**From:** [REDACTED]  
**Sent:** 19 January 2025 22:29  
**To:** Planning  
**Subject:** re LA01/2022/0791/F - OBEJECTION  
**Attachments:** Planning objection Jan 25.pdf

**Planning – LA01/2022/0791/F**

Proposal: Full Planning Application for residential apartment scheme comprising 6no apartments, landscaping, access off Causeway Street and ancillary works.

**Objection and Challenge of detail within planning report**

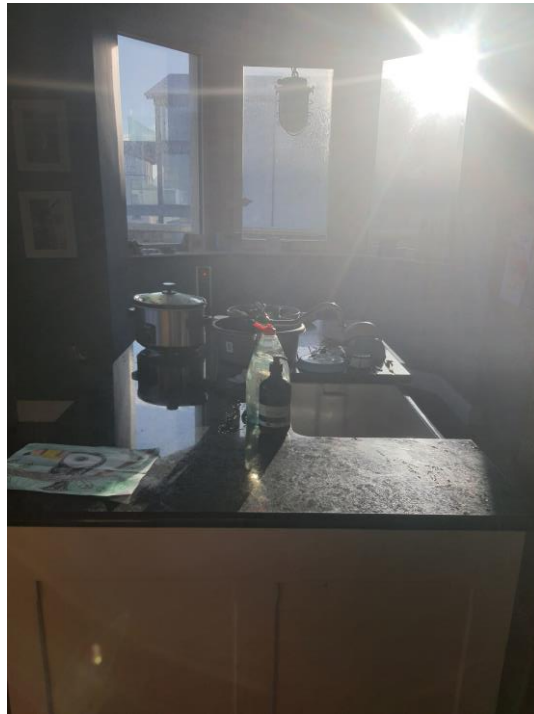
Point 8.57 however makes the sweeping conclusion that this proposal will result in overshadowing but the impact is not deemed unacceptable. This is made without sufficient evidence. Please find below photographs showing sunlight and daylight currently enjoyed via this kitchen window

This is the south facing and only window into our kitchen and you can clearly see how much daylight and sunlight it currently receives. All sunlight and daylight in these photos will all be completely blocked out by the proposal.

**INTERNAL**

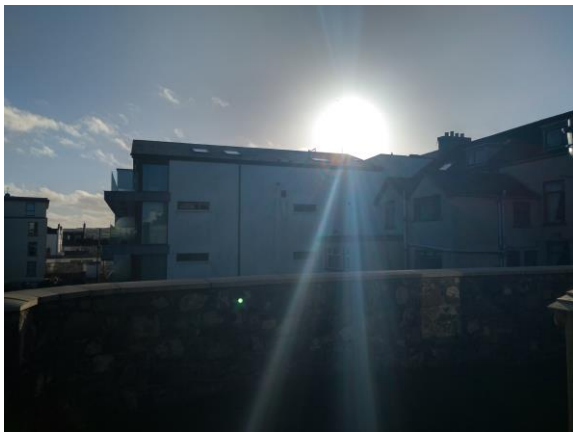
Please see further images showing the impact the new 3 storey extension will have, where the blue represents the new building.

Complete block out of sunlight.

Almost complete block out of daylight all year round.

## External shadow

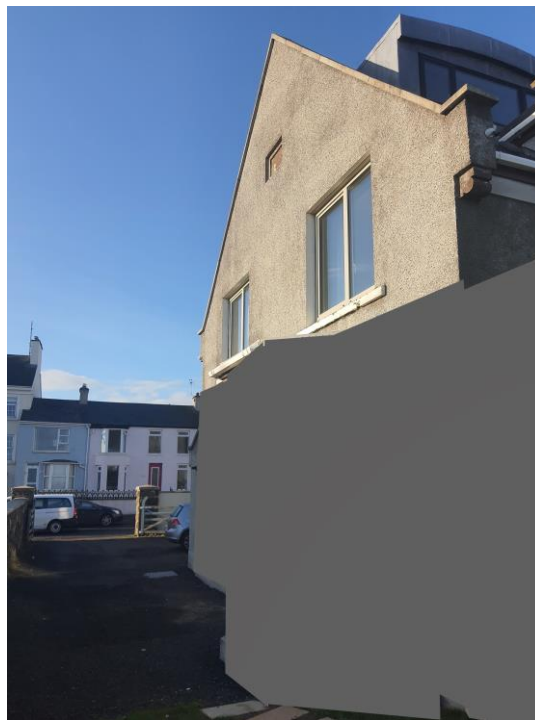
To help illustrate the degree of overshadowing, please see current shadow pattern externally.

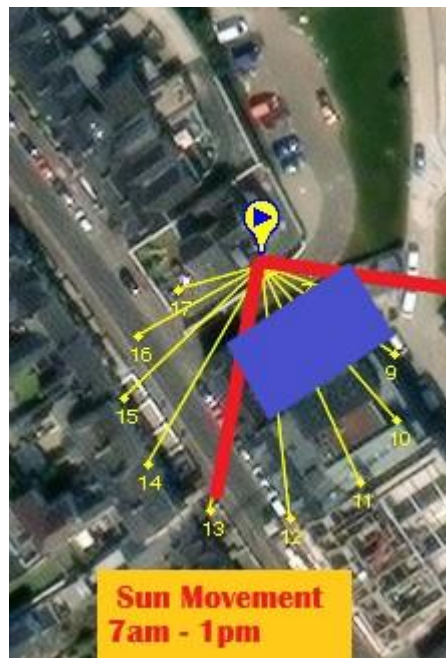
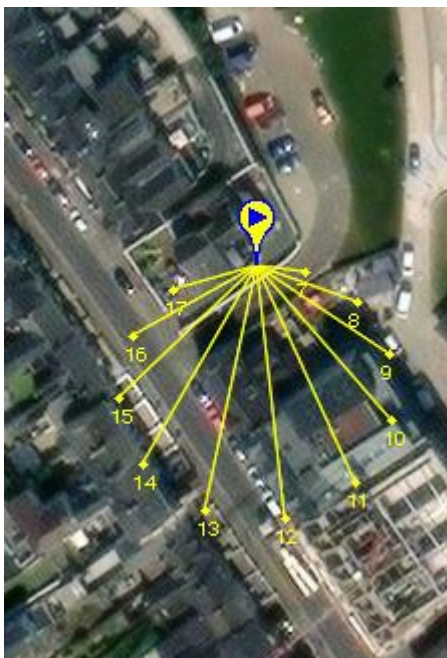
Kitchen window in foreground enjoying full sunlight, and illustration on the right showing height of shadow that the new extension will cast blocking out our whole window.

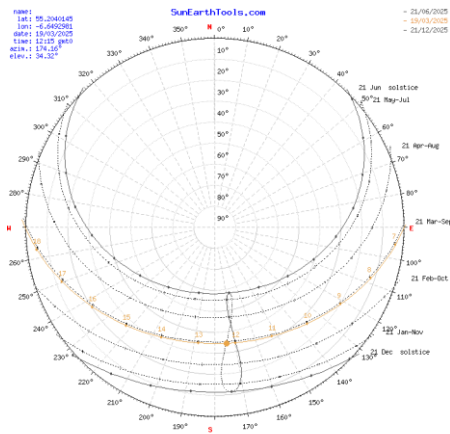
Point 8.59 makes reference to the sunpath, describing it without meaningfully showing the impact. Please find diagrams to evidence the impact.

Equinox sun pattern with evidence of how much of the day the application will block out for at least 6 months of the year.

Sun height pattern for 53 causeway street, showing height of current proposal will impact ground floors windows in shadow for at least 6 months.
